Heritage Impact Assessment

**New Campus Development for
The Ottawa Hospital
Phase 4: Main Hospital Project
Ottawa, Ontario**

**January 12th, 2026
(Issued for SPC Resubmission)**

HERITAGE IMPACT ASSESSMENT ADDENDUM 05 MEMO
New Campus Development for The Ottawa Hospital
Phase 4: Main Hospital

<p>View at the Healing Garden Further details are available in the NCD Indigenous Peoples Advisory Circle (July 17, 2025) presentation.</p>
5.27	South border near Maple Drive/CUP and Parking area

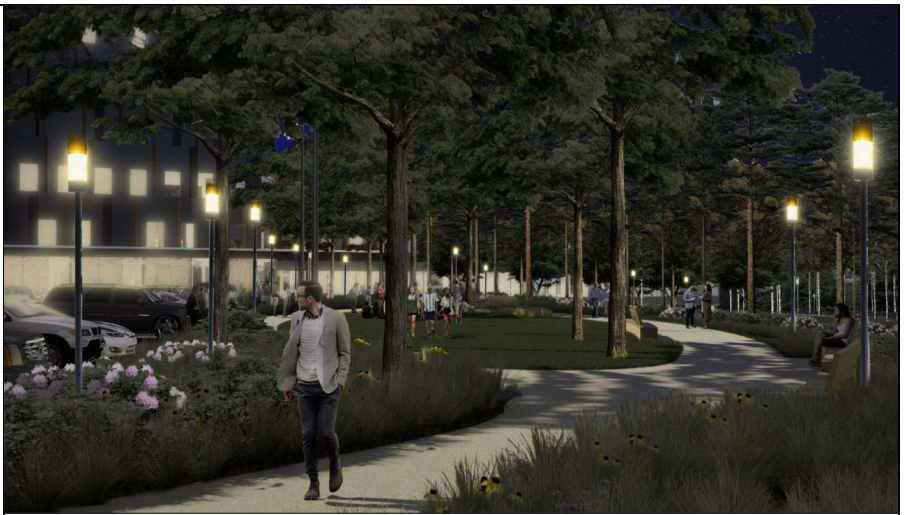
<p>5.16</p>	<p>Heritage staff will be looking for further updates related to any non-traditional mitigation strategies that have/are being considered:</p> <p>Views from patient beds to the surrounding landscape</p> <p>Landscaping planting/species choices</p>	<p>Views from patient rooms to the surrounding landscape will include views to the CEF as well as the new proposed main entrance courtyard. No significant views are impacted, thus no mitigation is required.</p> <p>To discuss: a clarification is needed to understand how this is a mitigation or impacts heritage.</p> <p>The dominant species of the mixed forest along the southern stretches of the Ottawa River are Maples, White Pine, Red Pine, Eastern White Cedar, Tamarack, White Spruce, Red Oak, Basswood, Ash, Poplar, Yellow Birch, and White Birch. Along the northern stretches of the Rideau Canal, coniferous trees dominate, including Jack Pine, Black Spruce, White Spruce, Balsam Fir, Trembling Aspen, White Birch, and Balsam Poplar. Taking advantage of these species, incorporating ornamental and</p>

<p>Interpretation/commemoration</p>	<p>rare/endangered species (i.e., Butternut – <i>Juglans cinerea</i>) into the Site, provides opportunities to study how these species interact with urban matrixes over a long period of time and their potential for further landscape use throughout the City of Ottawa.</p> <p>The following commemorative strategies are recommended: Commemorative Courtyard / Sculpture Garden & Healing Garden Opportunity to reflect the CEF's agrarian heritage and create a contemplative space for patients and visitors while reinforcing the site's identity. Incorporate native plantings, interpretive panels in collaboration with AAFC of the Friends of the Farm.</p> <p>The center landscape is an open lawn space, flanked by two stately groves of evergreen trees that are pruned high to allow filtered views through the trunks. A rich, layered understory grows in height towards the emergency entrance and exit ramps, softening and screening their length. In the distance, the hospital entrance is clearly defined by a line of columnar deciduous trees and flagpoles, working in concert with the architectural façade and signage to encourage instinctive wayfinding.</p> <p>To the west flank of the approach garden, the Indigenous Healing Garden is an important node of the overall campus landscape. Not only is it carefully designed to capture key Indigenous principles, but this crafted, natural, tactile garden is an idyllic moment of reflection, recovery and repose in the campus.</p> <p>The lightwell will be a dedicated space to acknowledge Algonquin peoples and Algonquin land as well Indigenous peoples living in Ottawa and region and the many treaty and non-treaty lands in the TOH service region, which includes Mohawks of Akwesasne, the Baffin region of Nunavut. The space will include an art installation representing the three recognized Indigenous groups (First Nation, Inuit and Métis) as well as living plants, rock, and (rain) water.</p> <p>Light Well as location of Land Acknowledgment:</p> <ul style="list-style-type: none"> • Is at the heart of the site • Highly visible from Main Entrance and adjacent corridors on multiple levels • Opportunity for Land Acknowledgment to be spatial and exposed to the elements: land, sky, sun, shadow, rain and snow  <p>Proposed Landscape Site Plan illustrating the healing Garden and the Light well</p>
